URBAN PLANNING DELEGATED COMMITTEE REVISED AGENDA

3.1 1 Creswick Street, Hawthorn (Construction of an additional dwelling on a lot) - PP21/0139

PLANNING ASSESSMENT Urban Planning Delegated Committee

Application Number	PP21/0139
Date Application Received	23/02/2021
60 Day Statutory Time Frame	12 April 2024
Planning Officer	Timothy Luckin

Figure 8 - Proposed landscaping

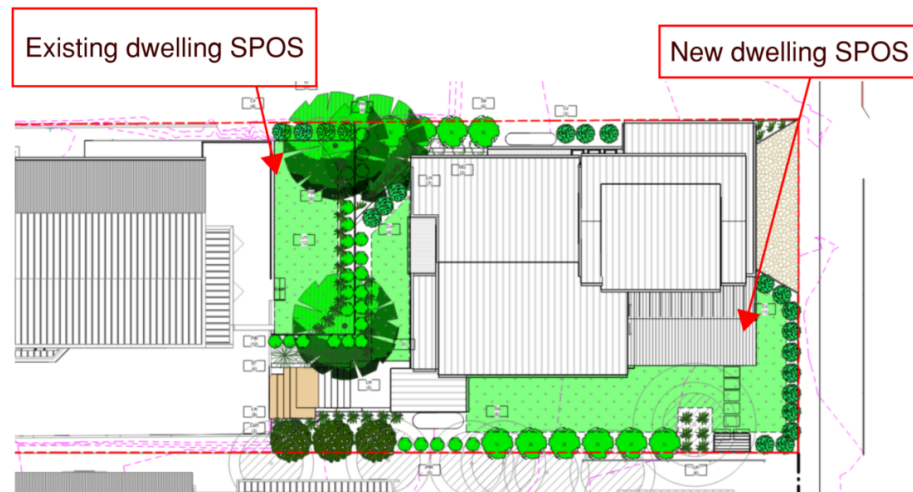
Both the new and existing dwelling have SPOS areas which have a minimum dimension exceeding 3m. A screenshot of the landscape plan is shown in Figure 8 below and

demonstrates there will be large areas provided for new planting including trees. Conditions will require a new small tree to be planted in each secluded private open space.

- b. One (1) small tree (minimum 2 metres tall when planted and must achieve a minimum mature height of 7 metres and canopy spread of 5 metres) in the rear secluded private open space of the front dwelling;

- c. One (1) small tree (minimum 2 metres tall when planted and must achieve a minimum mature height of 7 metres and canopy spread of 5 metres) in the secluded private open space of the new rear dwelling;

Tree 10 - approx location and TPZ/SRZ

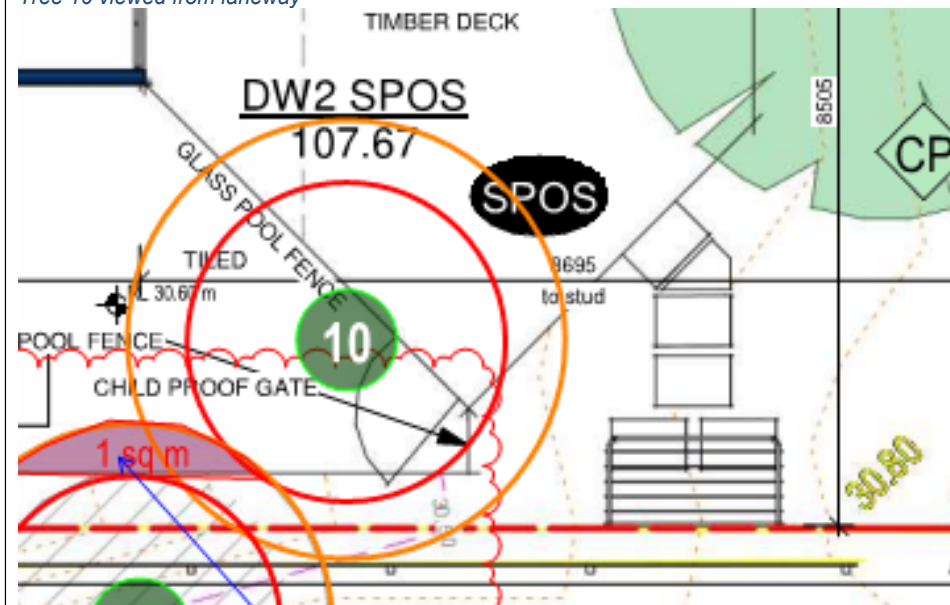
Note: following submission of the S57A plans, this requirement has been satisfied. The only change needed is to move the clothesline out of the TPZ of Tree 10.

This tree has been identified in the arborist report as being of low retention value due to its health, structure and issues with wood borers. The tree is of relatively low amenity and retention value with borer damage observed within the main trunk and branch attachment. The removal of this tree does not require a local law permit. The tree could be retained with the deletion of parts of the deck and reconfiguration of the pool fence, but given its condition, size and potential impacts to property in the future, its removal with more suitably located replacement planting is considered a good outcome.

- g. The front dwelling's storage area to be shown on the floor plans in accordance with Standard B30 (Storage).
- h. Proposed clothesline and associated pavement to be located outside of Tree 10's Tree Protection Zone.

01 PROPOSED EAST ELEVATION
1:100@A1

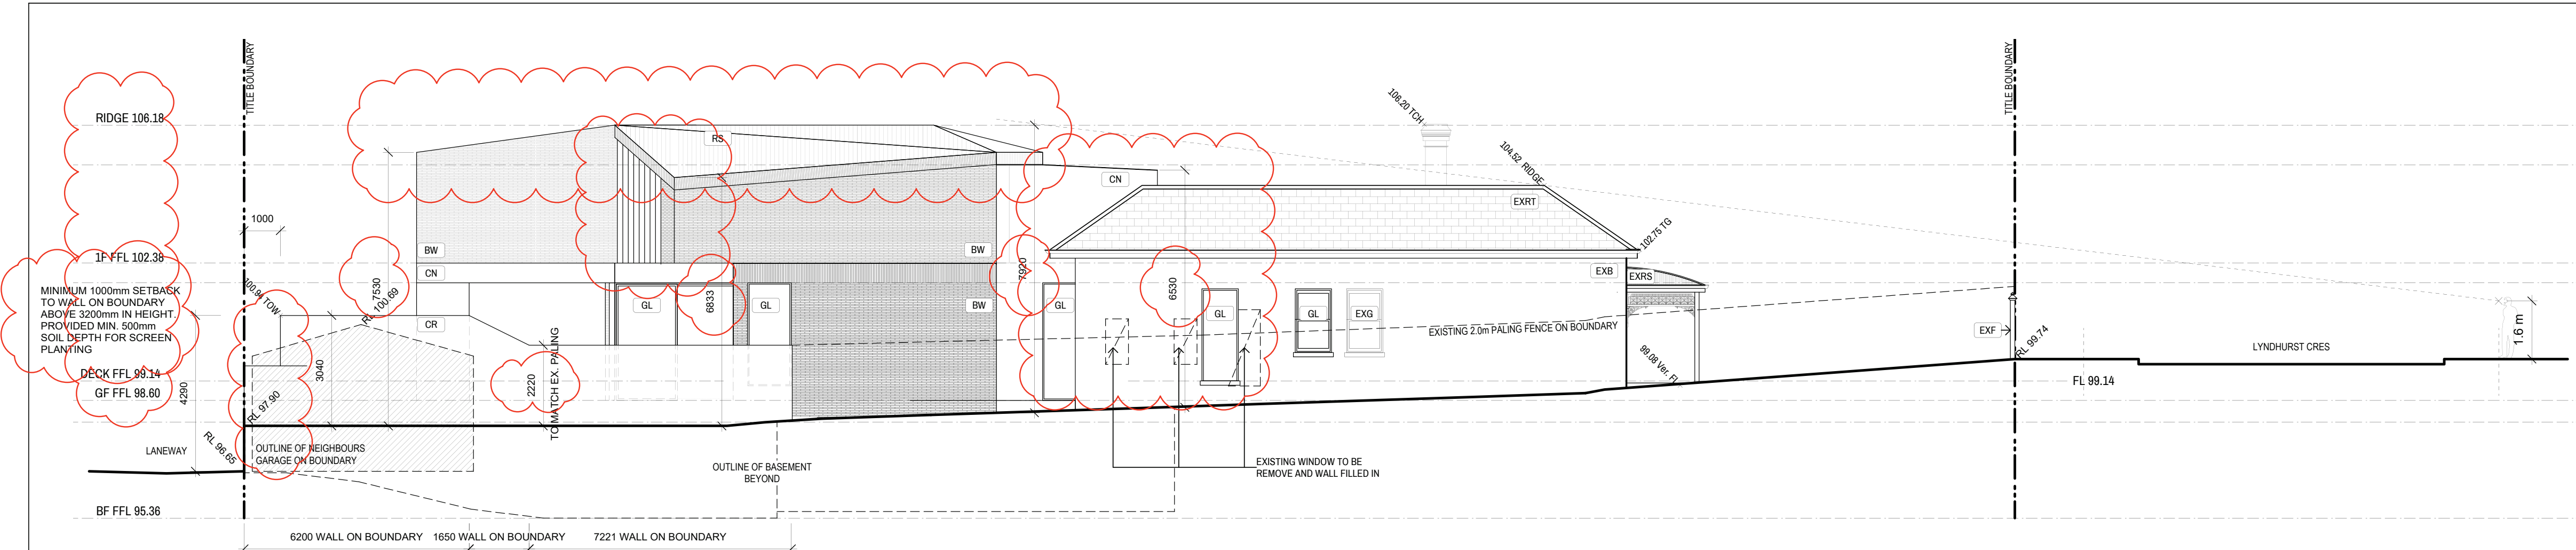
The design response provides for a basement, ground and first-floor. The basement is accessed via the rear laneway, which provides for 2 car parking spaces, vehicle turning circle and additional rooms.

The ground floor siting extends beyond the existing setbacks of the host building. The western siting is built to match existing wall on boundary with the adjoining property. Given the slope of the site, the ground floor addition will have limited visibility and sits below the eaves of the existing building, which ensures it reads as a subservient, secondary element.

04 PROPOSED NORTH ELEVATION
1:100@A1

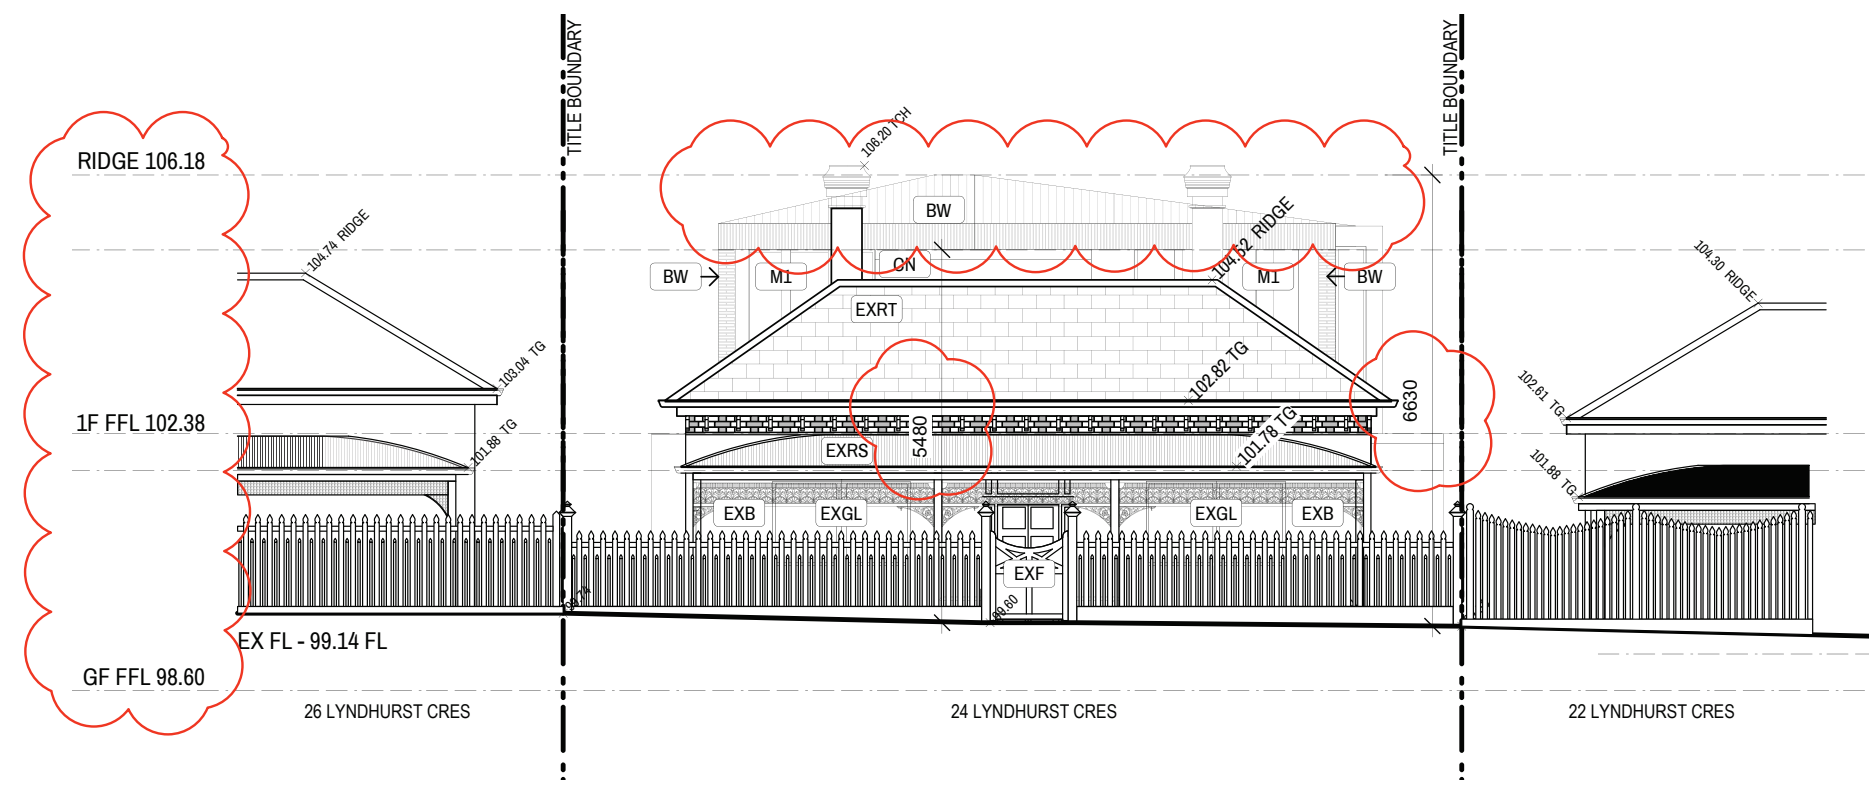
8	<i>The ground floor built form of the addition be clearly depicted in the proposed northern elevation in the next iteration of drawings</i>	<i>The proposed northern elevation (at Drawing TP09) does not appear to show the ground floor built form extending to the property boundary to the west.</i>	<i>Actioned</i>
